PROPOSED PLOT PLAN

HEALTH DEPARTMENT
ENVIRONMENTAL HEALTH DIVISION
700 NORTH TRYON STREET
CHARLOTTE, NC 28202
PHONE (704) 336-5102

FILE: 4222B

TC: 199-331-30 PO

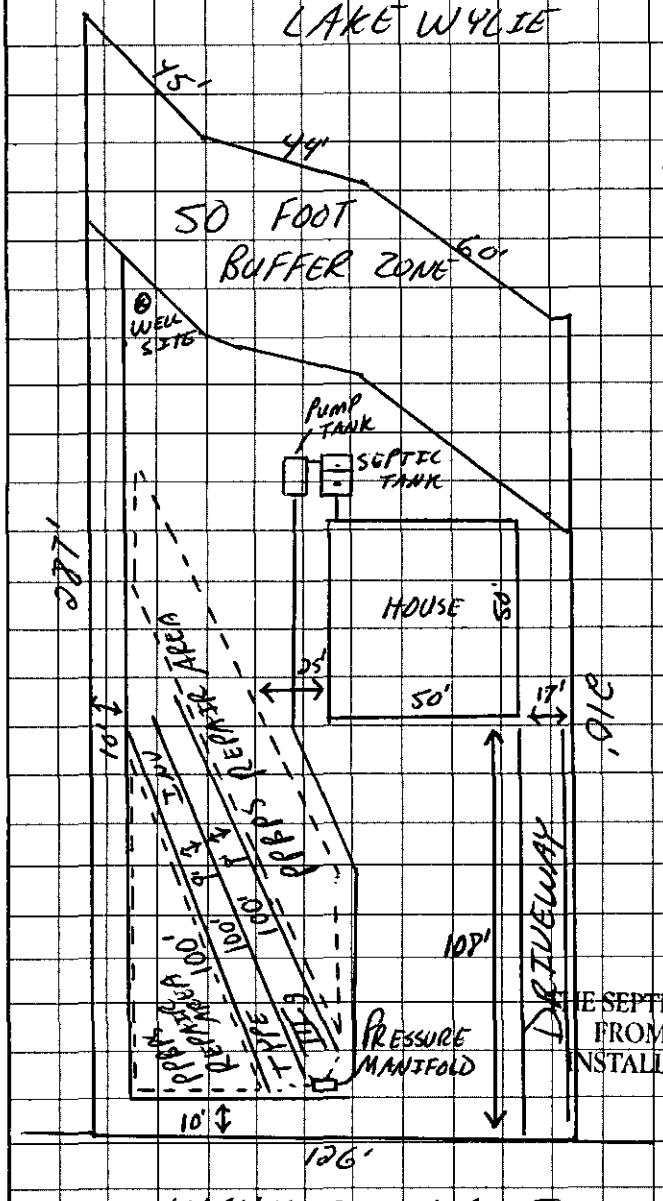
→ SCALE = 1" = 50'
→ Keep lines level and on contour of the land.
→ Keep trenches shallow (24" Max)
→ Keep all parts of the system the minimum distances from the following:
  → 10' off property lines
  → 25' from foundation drain
  → >50' from all wells
→ System designed for 3 bedroom House
  - Install 3 lines x 100'
  Type III b Innovative System
  Pressure Manifold
→ Type III PPBPS Repair System
→ House located 108' off property (front) line.
